工程指示 / 要求簡箋 ENGINEER INSTRUCTIONS(E.I.)

工程指示編號:	EI- 8899	修改版本:	G
	HK- 0388		
工程編號:	J 861	工程名稱:	己連拿利
收件人:	生統/技術部	發件人:	細佬
工程項目:	幕牆	日期:	06/05/2025

PROJECT: PROPOSED RESIDENTIAL DEVELOPMENT AT NOS. 3-6 GLENVALE, CENTRAL, HONG KONG

TITLE: TYPICAL TRANSOM DETAIL FOR CURTAIN WALL

1 TYPICAL TRANSOM DETAIL
6007 CURTAIN WALL

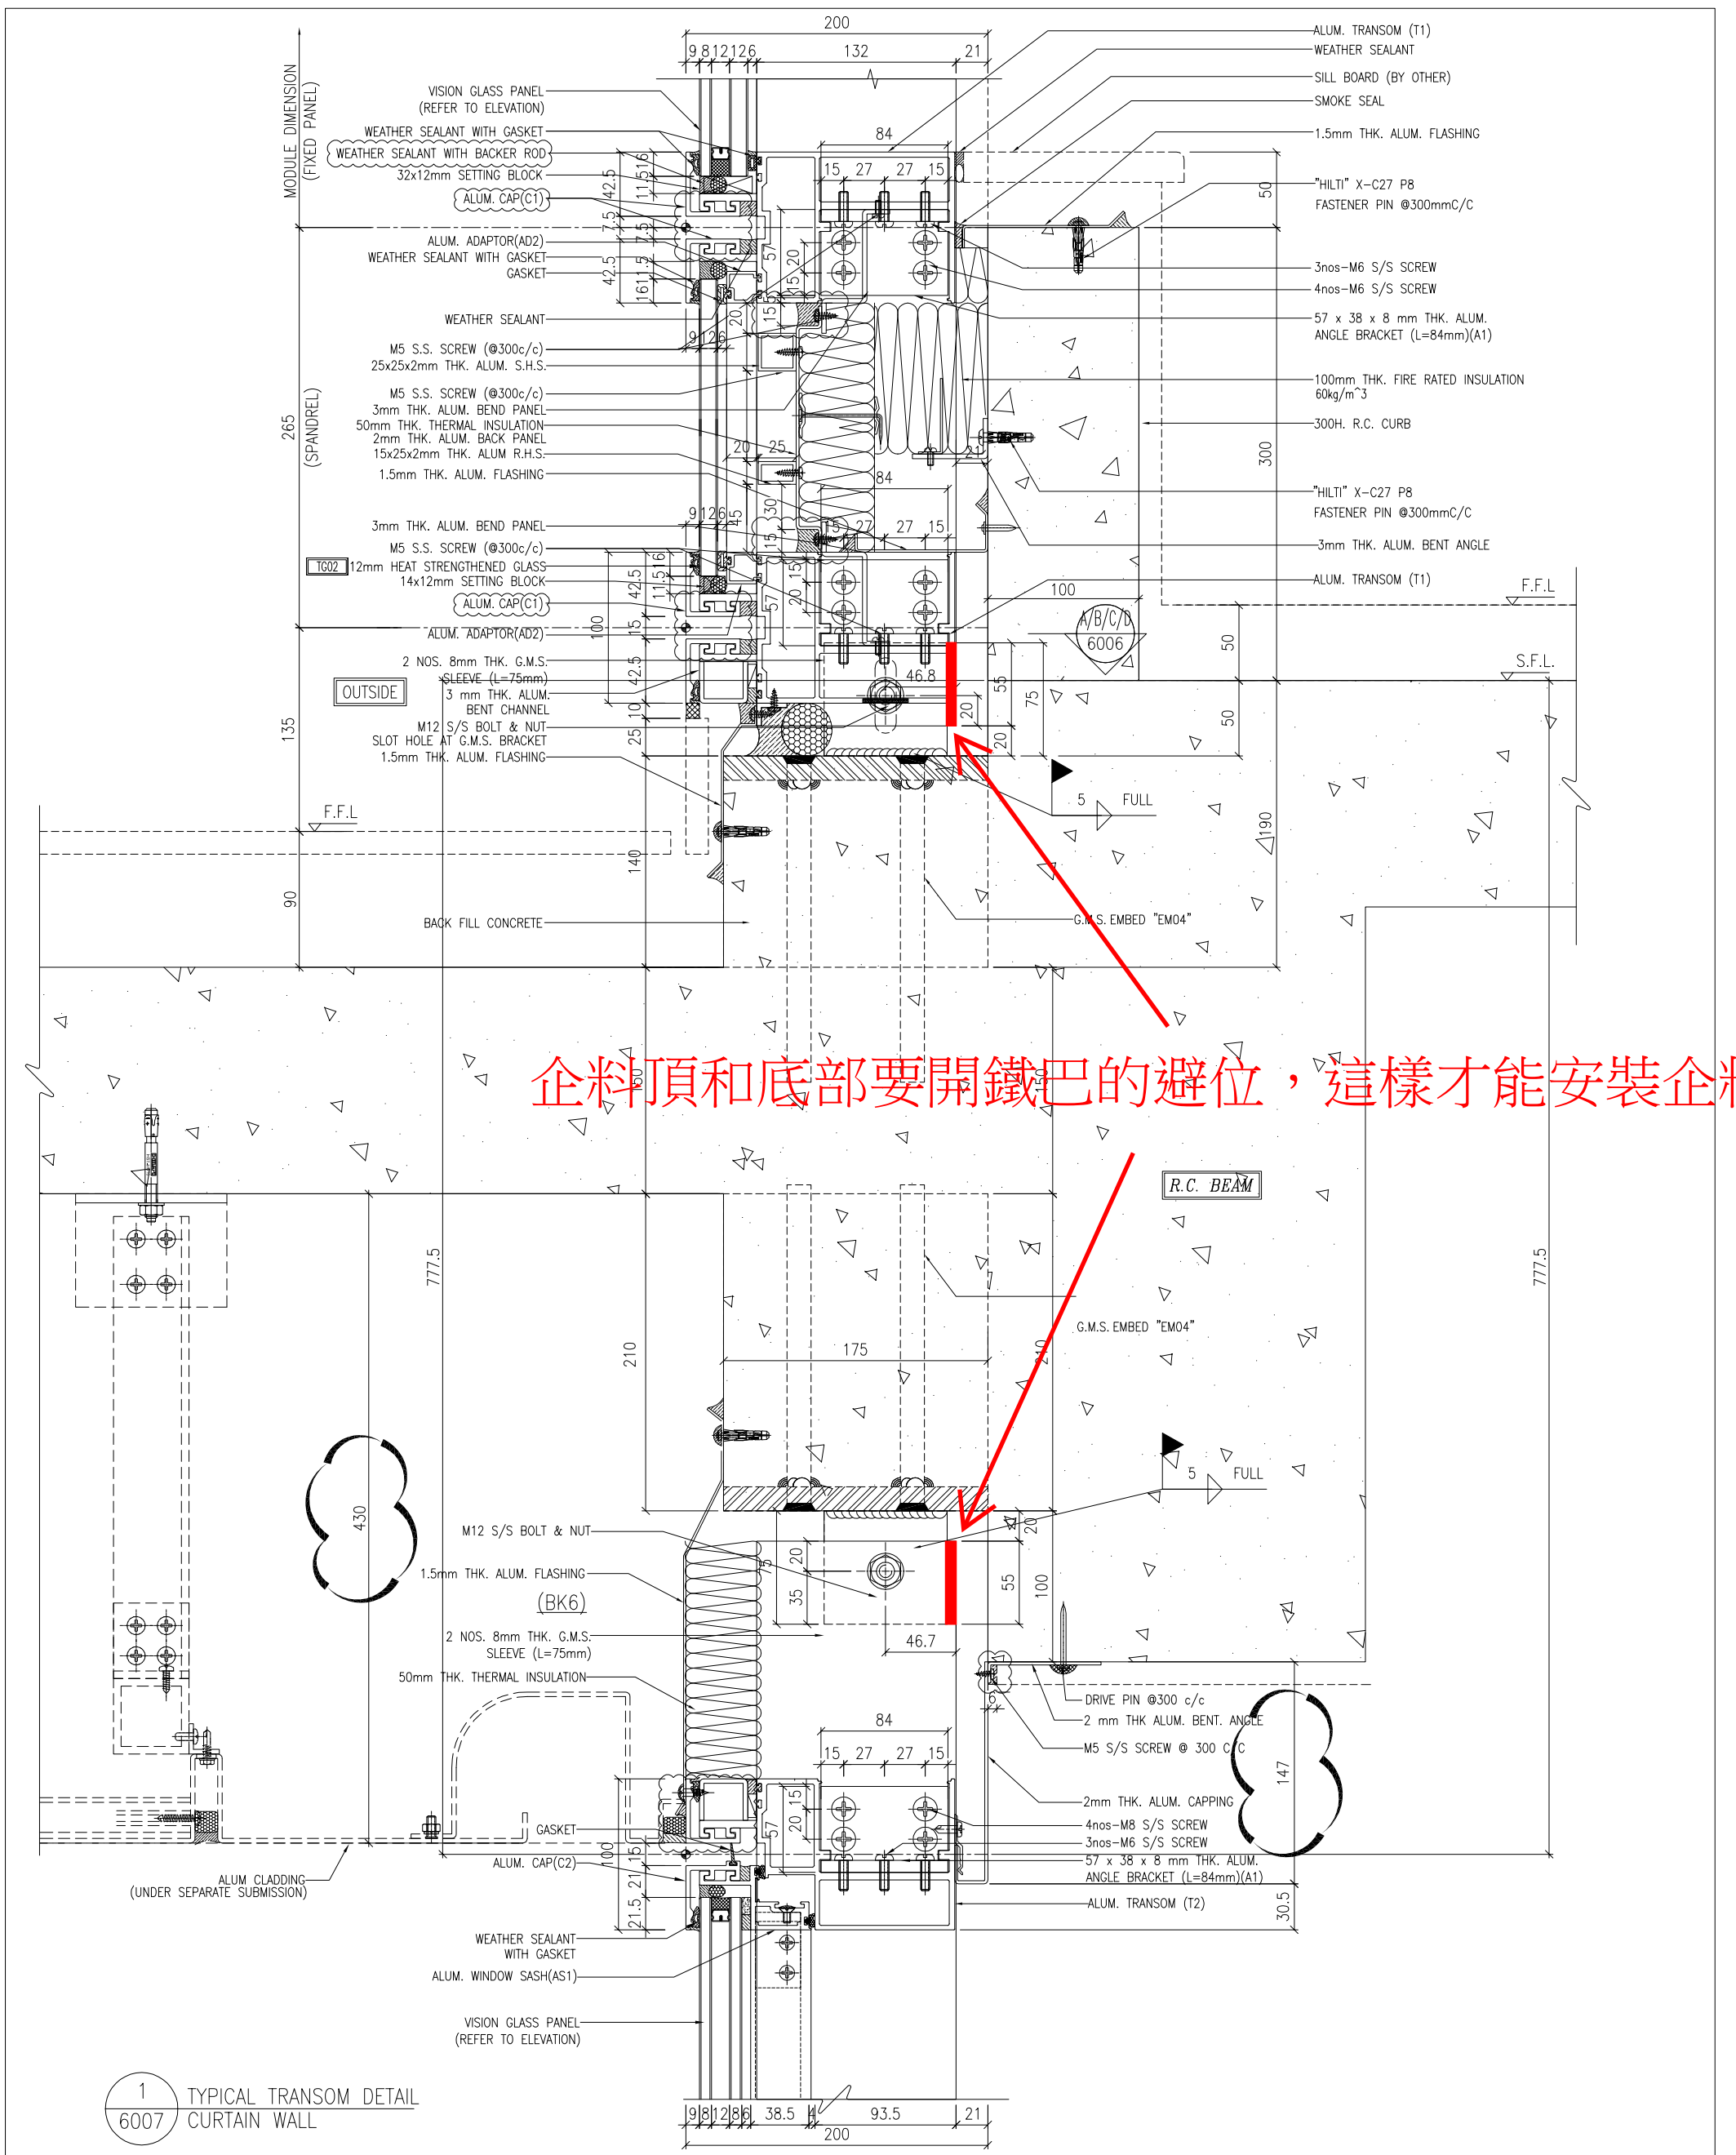
企料頂和底部要開鐵巴的避位，這樣才能安裝企料

企料頂和底部要開鐵巴的避位，這樣才能安裝企料

內容:	給技術部: 看附頁的問題, 企料頂和底部要開鐵巴的避位, 請修改有關的加工圖
完成上列要求日期:	08/05/2025

1 PART ELEVATION
CURTAIN WALL

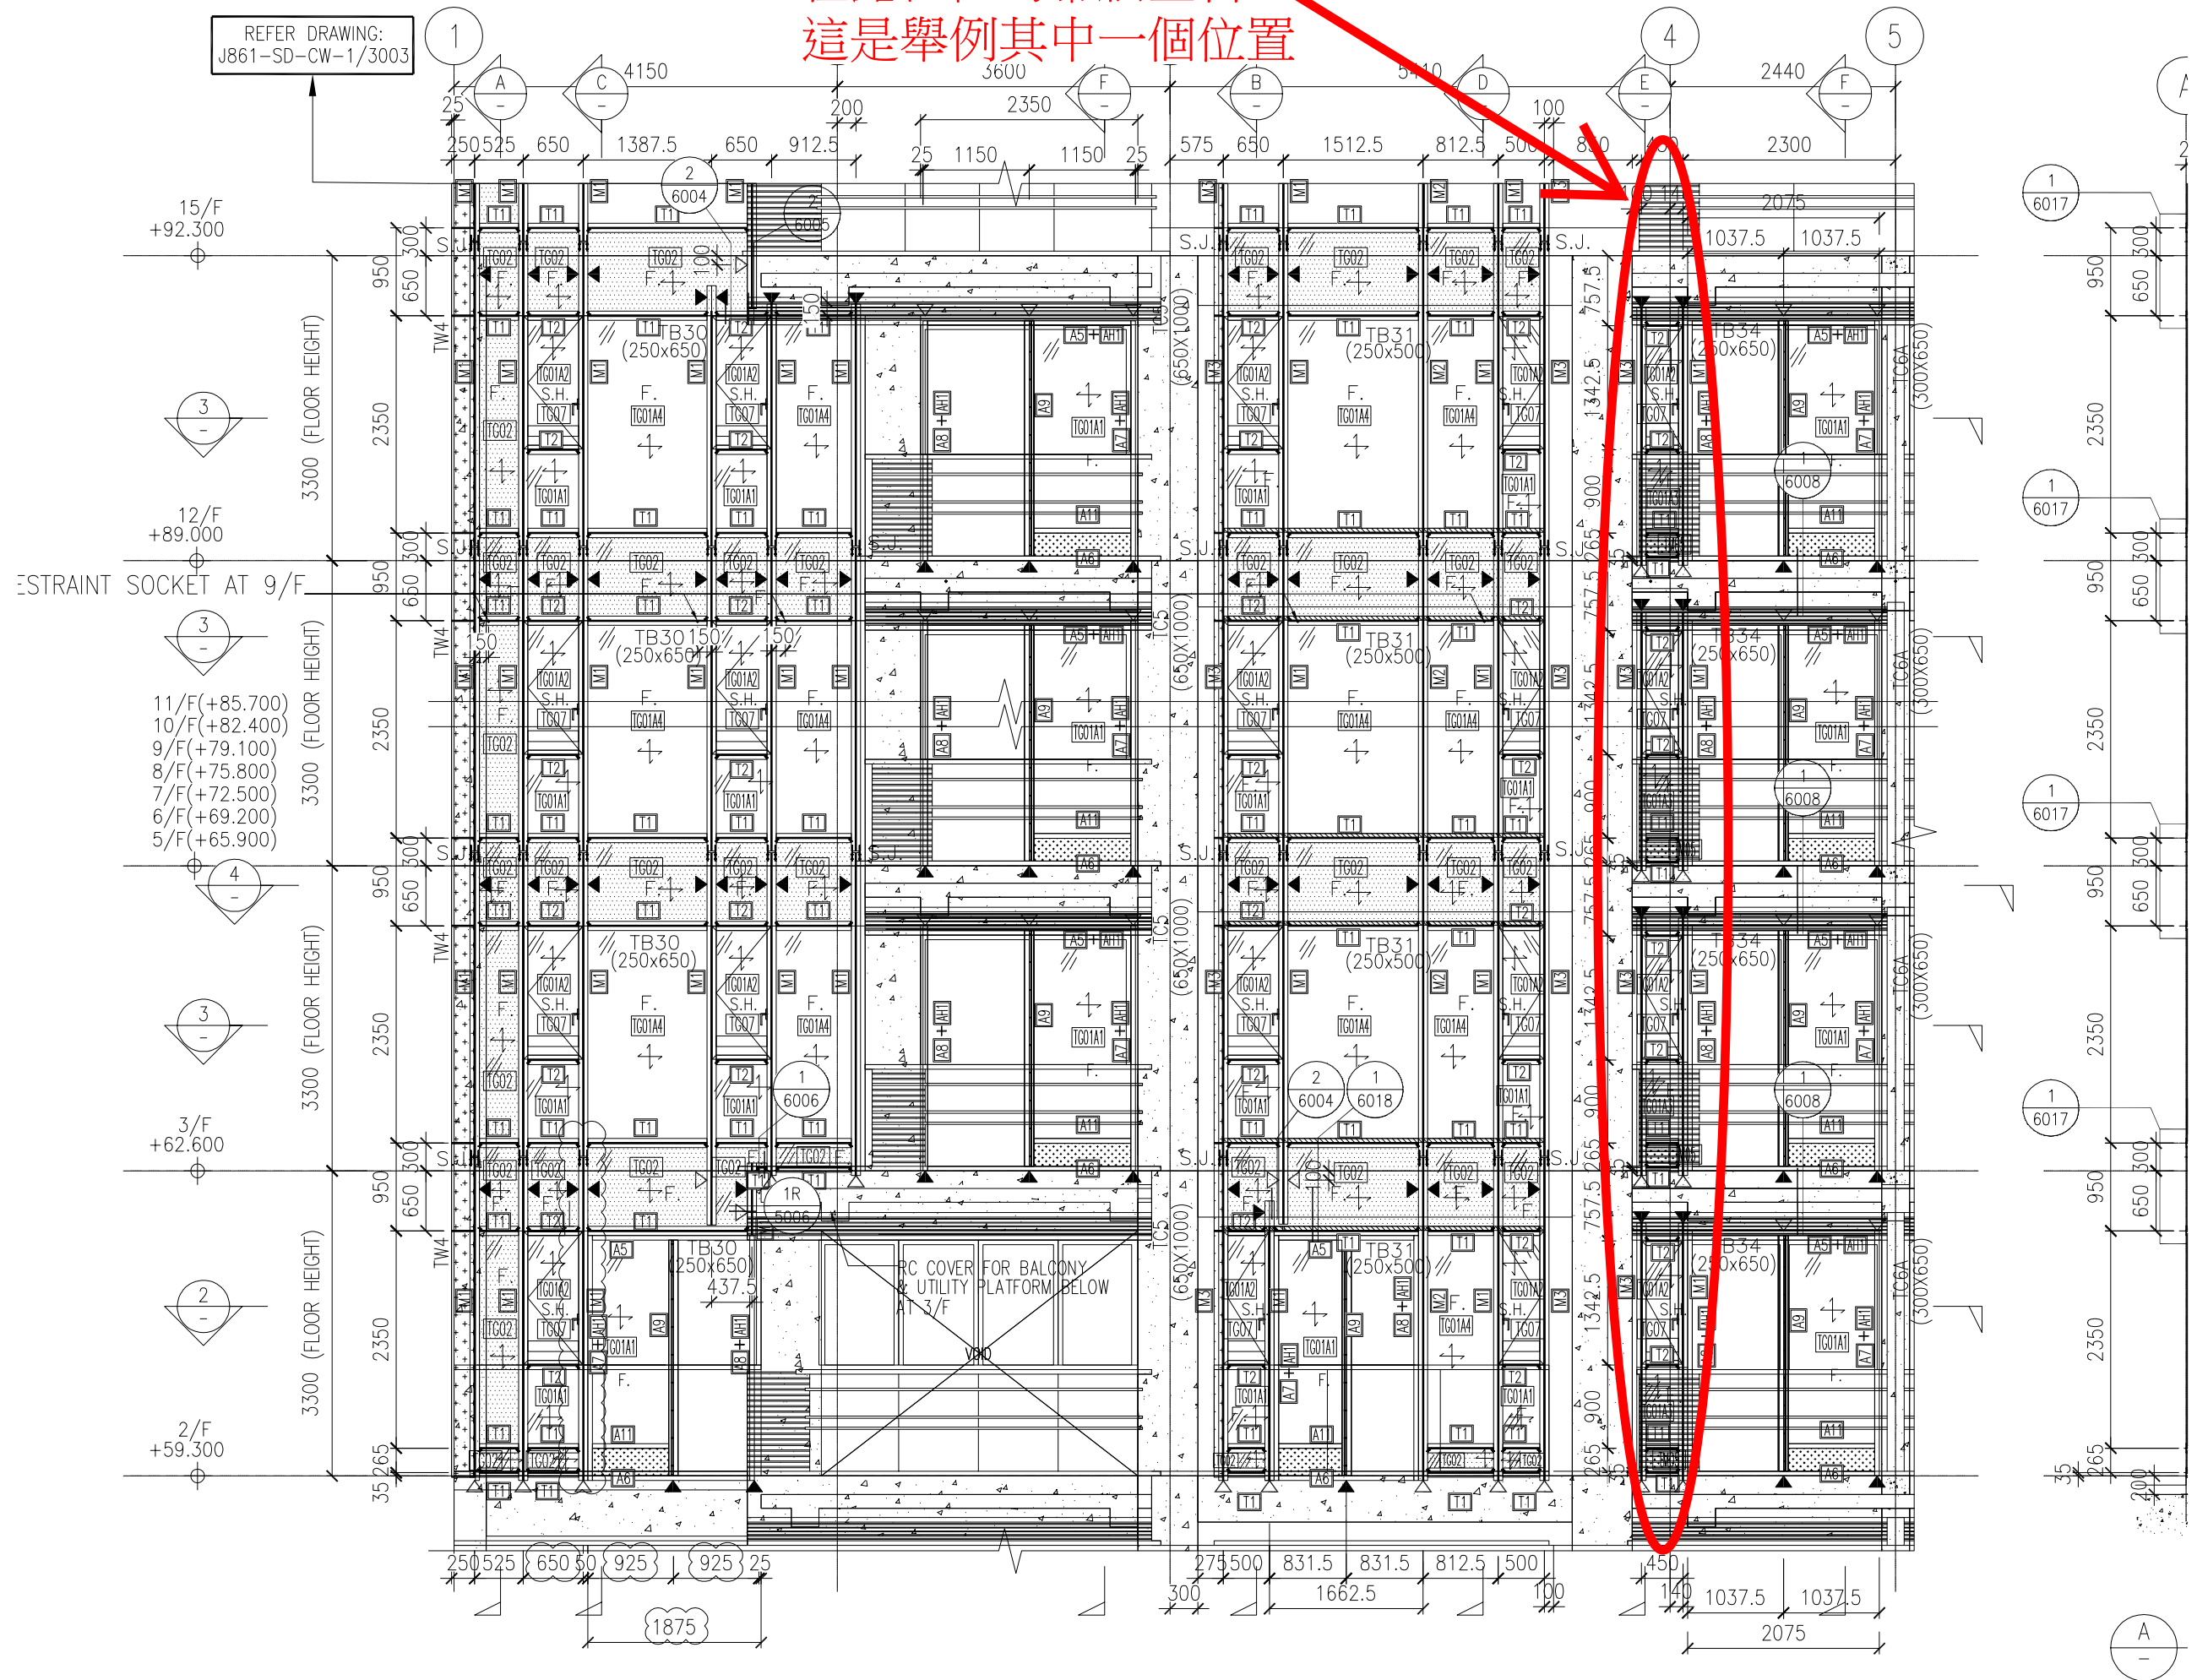
在露台位的幕牆企料
這是舉例其中一個位置
